DEVIATION REQUEST AND DECISION FORM

Project Name :	The Commons at Falcon Field	Deviation No. 2b – 2/9/2024; rev. 4/3/2024 (Note: was previously part of Deviation 2 dated 6/2/2023)
Schedule No.(s) :	4307000001 and 4307200015	
Legal Description :	<p>TRACT IN SEC 7-13-64 DESC AS FOLS: BEG AT NW COR OF LOT 13 ARROWHEAD ESTATES FIL NO 1; TH S 00<46'12" W 197.28 FT ALG WLY LN OF SD LOT 13 TO A PT, N 41<58'50" W 798.01 FT TO SELY R/W LN OF US HWY 24, TH ALG SD SELY R/W LN ALG ARC OF CUR TO L SD CUR BEING CONCAVE TO NW HAVING A RAD OF 5800.00 FT AN ARC DIST OF 193.53 FT A C/A OF 01<54'42" WHICH CHORD BEARS N 47<22'56" E 193.52 FT, N 46<25'11" E 760.04 FT TO INTSEC SD SELY R/W LN OF US HWY 24 & WLY R/W LN OF RIO LN, TH SLY ALG SD R/W OF RIO LN S 22<22'28" E 219.81 FT, S 89<10'21" E 1071.23 FT TO NW COR OF LOT 14 OF FALCON RANCH ESTATES SUB, S 00<10'51" E 705.04 FT ALG WLY LN OF SD LOT 14 & LOT 13 FALCON RANCH ESTATES SUB TO THE MOST NLY NW COR OF LOT 10 ARROWHEAD ESTATES FIL NO 1, TH CONT S 00<10'51" E 151.74 FT, TH N 88<55'44" W 1314.29 FT TO POB</p> <p>TRACT IN SEC 7-13-64 DESC AS FOLS: COM AT NW COR OF LOT 13 ARROWHEAD ESTATES FIL NO 1; TH S 00<46'12" W 197.28 FT FOR POB; TH CONT S 00<4

Deviation Exhibit A

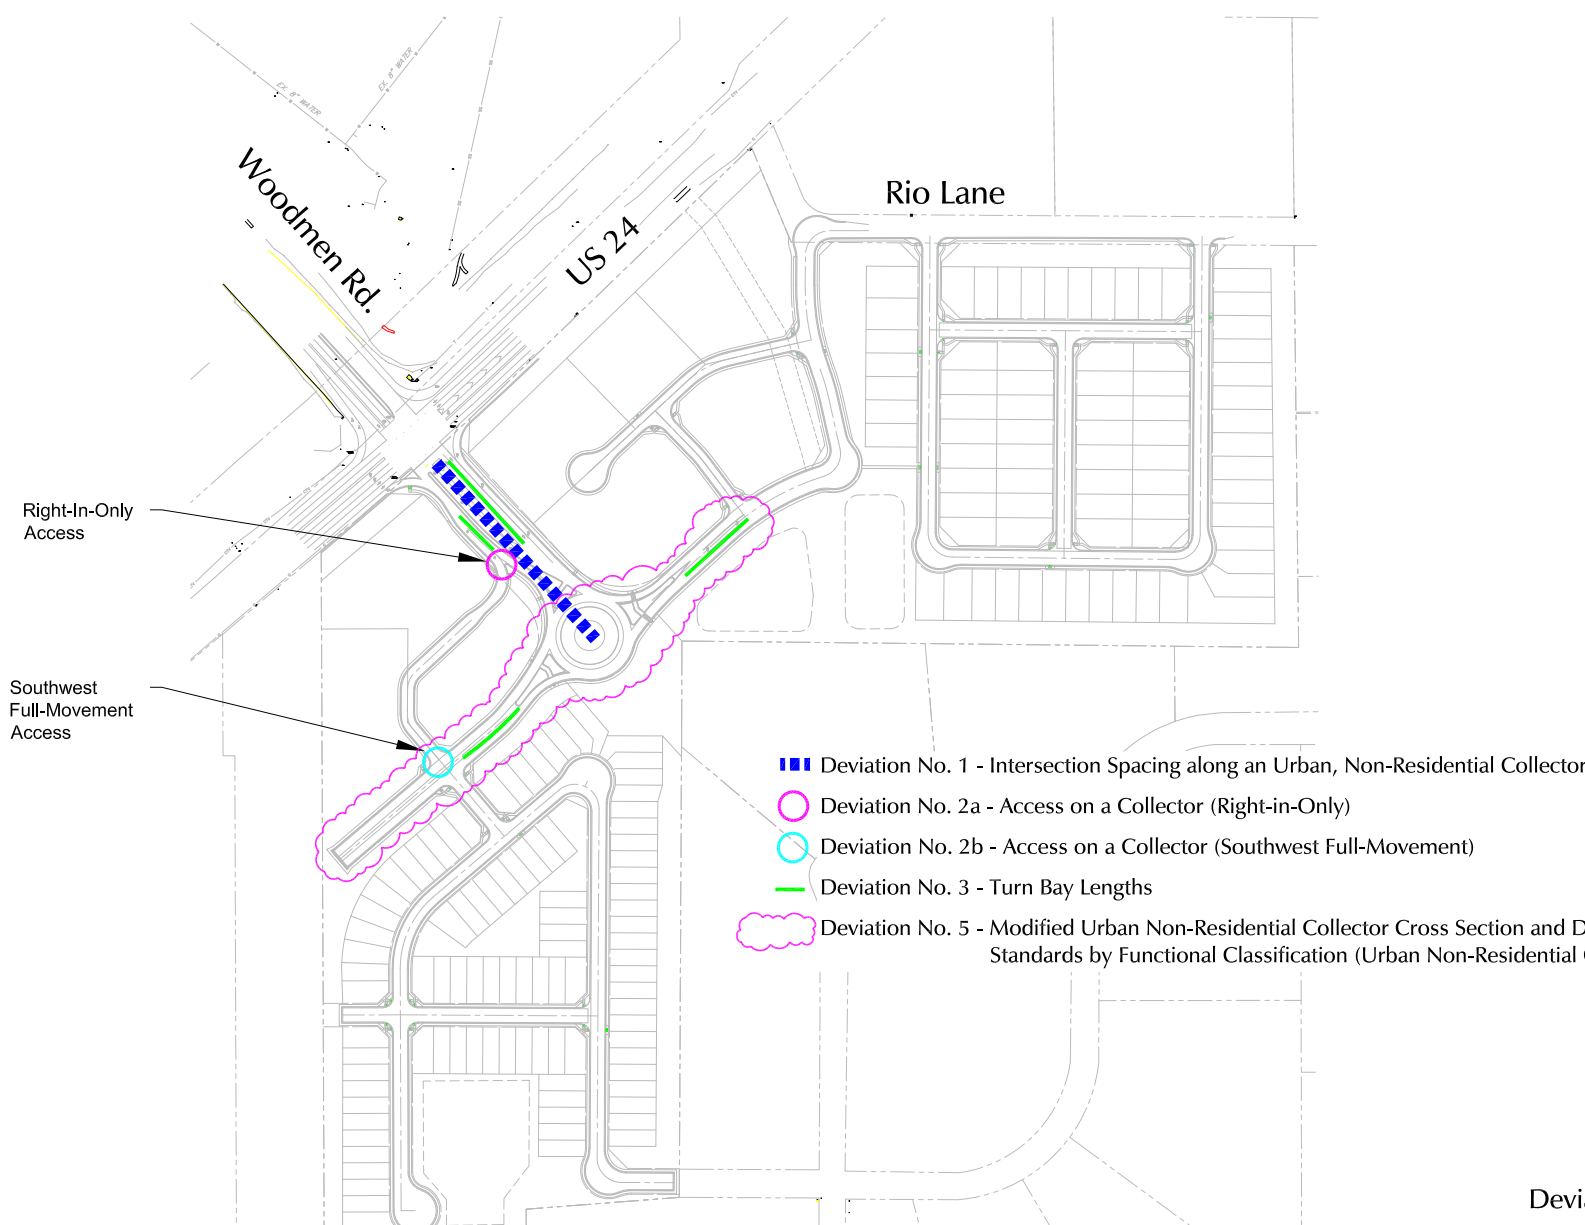
This deviation is one of four submitted with this application. Deviation Exhibit A (attached) graphically summarizes all four deviation requests, including this one. This requested access point (driveway) is shown on this exhibit. Deviation Exhibits 2b-1 and 3-2, and AutoTurn Exhibit No. 5 are also attached and are referenced below.

Deviation Exhibit 2b-1
Commons at Falcon Field (LSC# 234220)

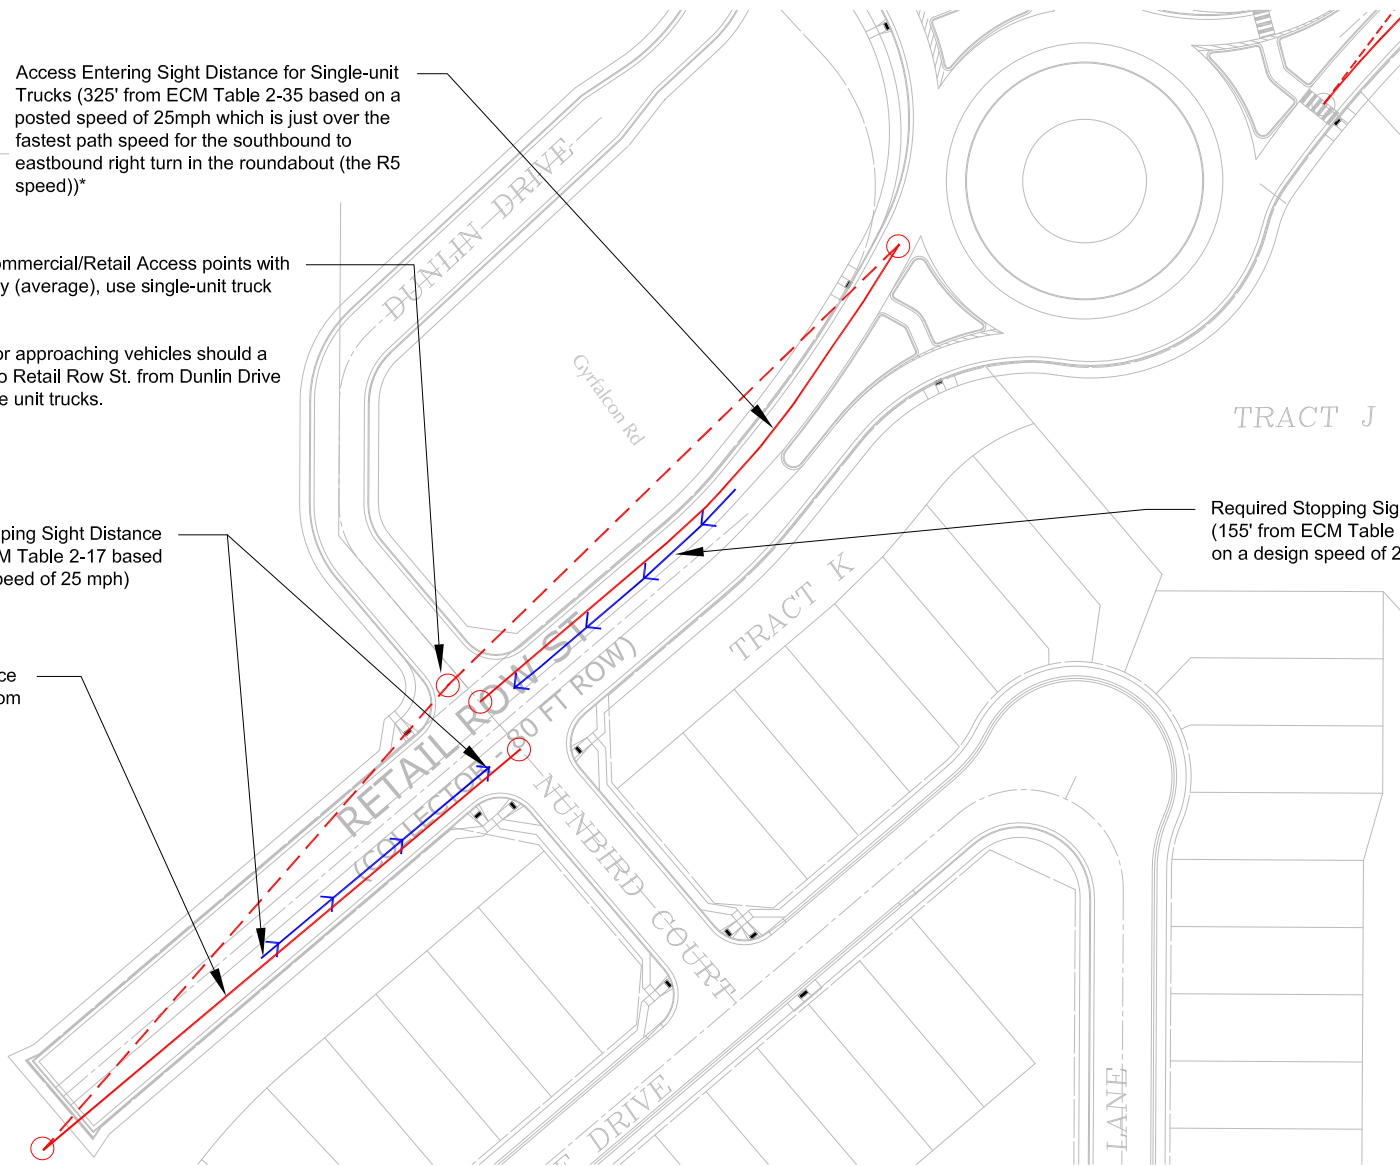
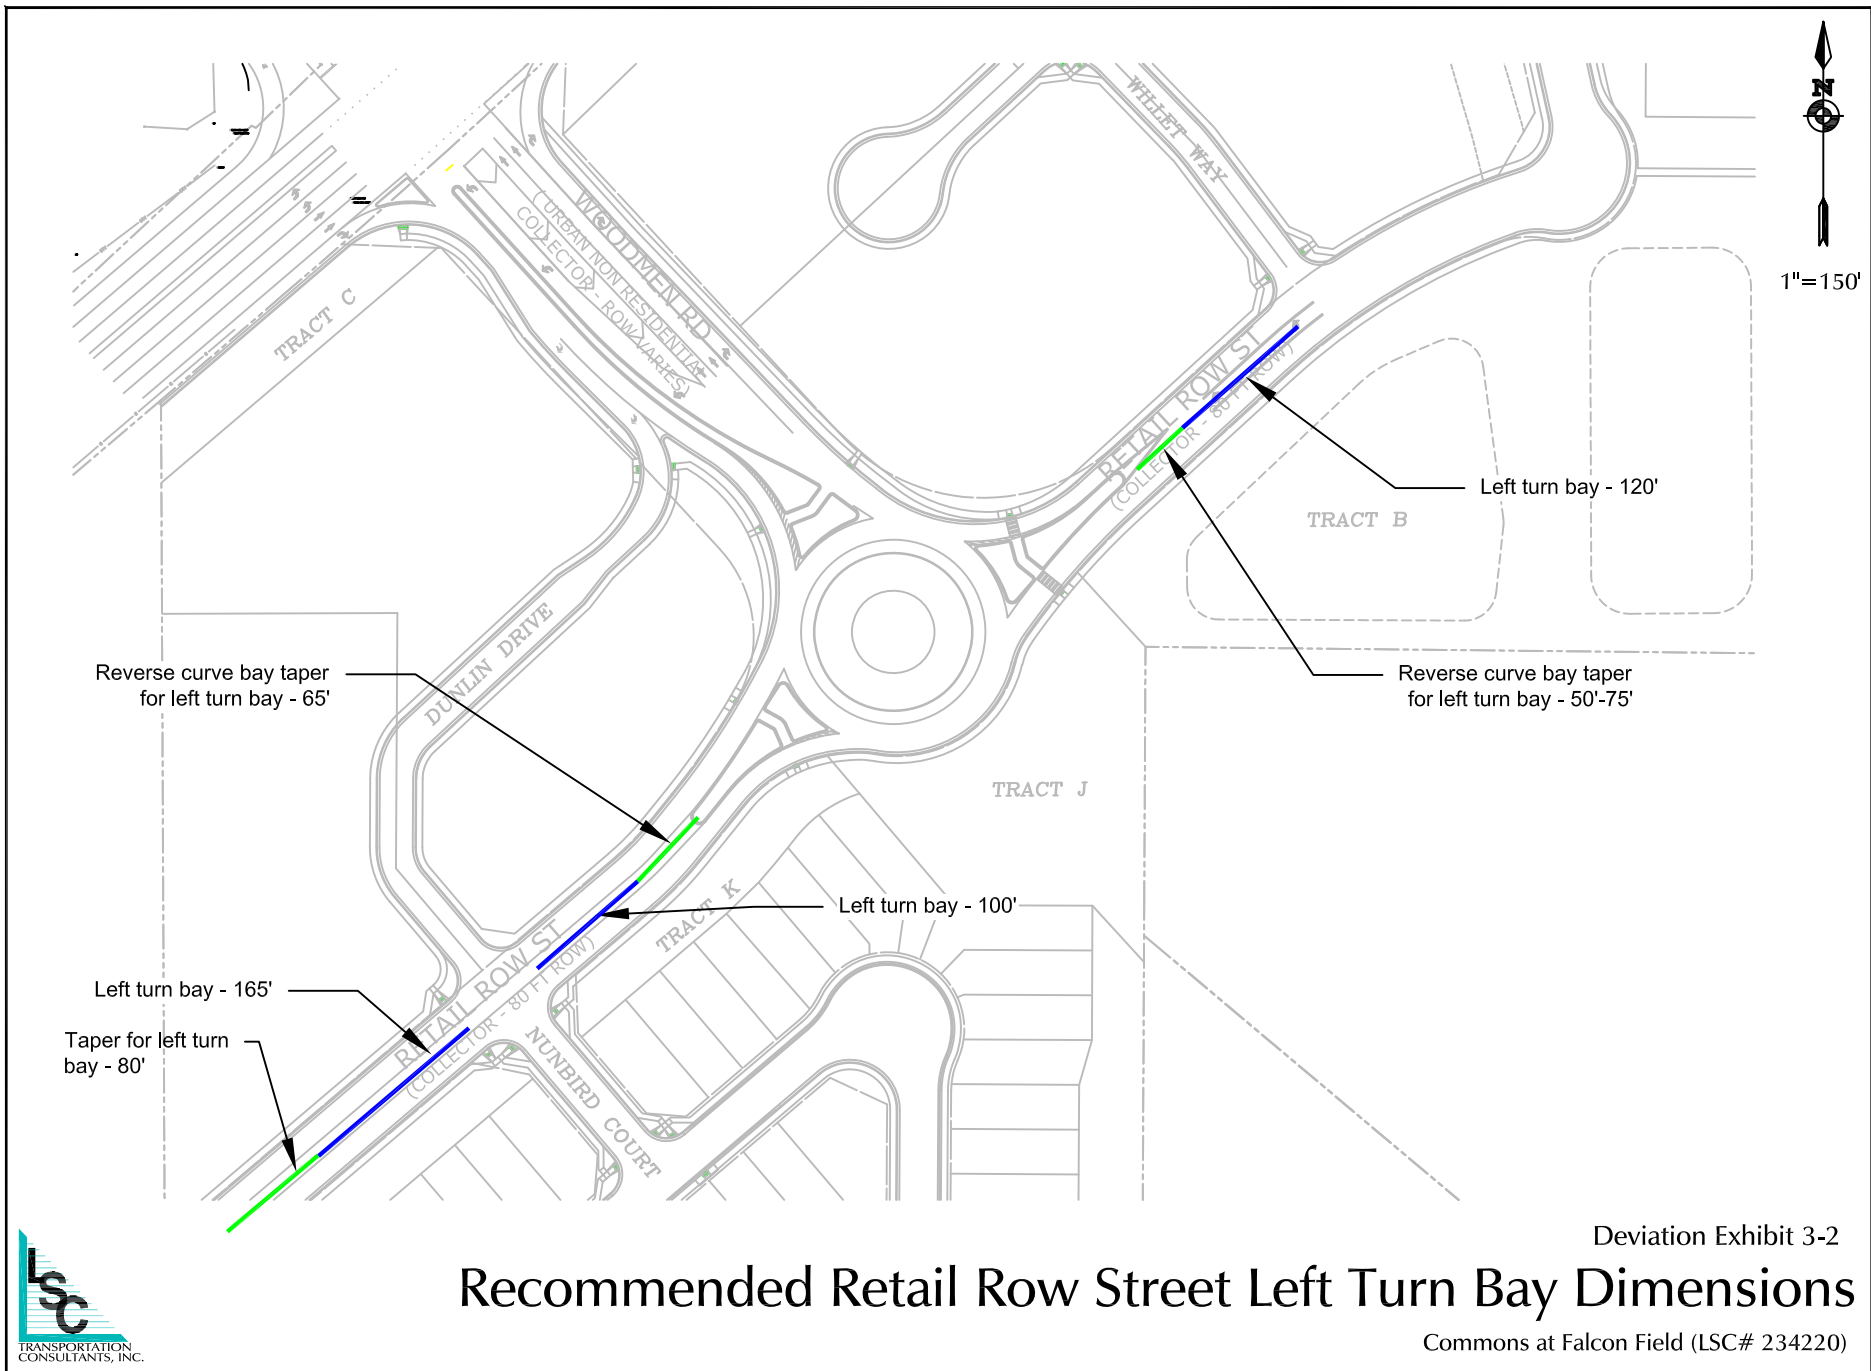
Exhibit 2b-1 shows a sight-distance analysis for the proposed access. As shown in this exhibit, this access would meet the criteria for stopping sight distance when considering the anticipated design speed of traffic turning from the roundabout.

Access Entering Sight Distance for Single-unit Trucks (325' from ECM Table 2-35 based on a posted speed of 25mph which is just over the fastest path speed for the southbound to eastbound right turn in the roundabout (the R5 speed))*

ECM Table 2-36 indicates for Commercial/Retail Access points with less than multi-unit trucks per day (average), use single-unit truck (which is shown on the exhibit).

There would be sufficient SSD for approaching vehicles should a multi-unit truck begin turning onto Retail Row St. from Dunlin Drive based on sight distance for single unit trucks.

Required Stopping Sight Distance (155' from ECM Table 2-17 based on a design speed of 25 mph)

*Note: based on AASHTO criteria, the departure sight distance to the left is 312' for a design speed of 25 mph. [AASHTO Green Book Section 9.5.3.2.1

AutoTurn Exhibit 5

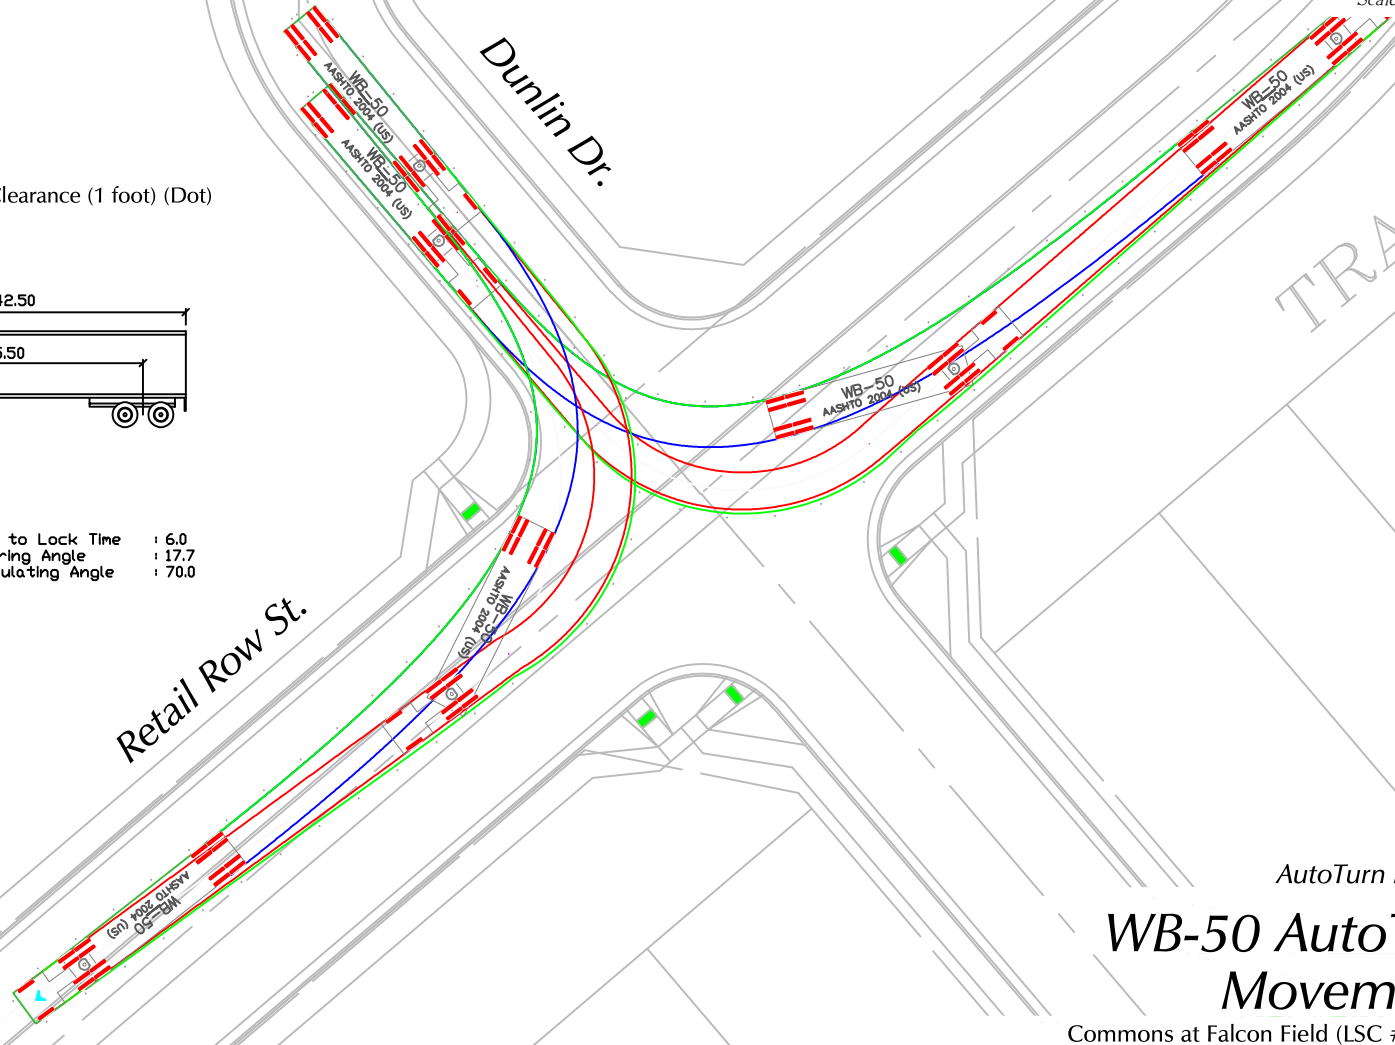
The ECM requires a minimum 25-foot width for a commercial access point on a Non-Residential Collector roadway. The site-access drive (30 feet wide minimum) would meet this criterion. The driveway radii of 20 feet is shown per Deviation No. 5. The attached AutoTurn Exhibit No. 5 shows the turns at the access based on AutoTurn truck-turning template of the design vehicle (WB-50 multi-unit truck).
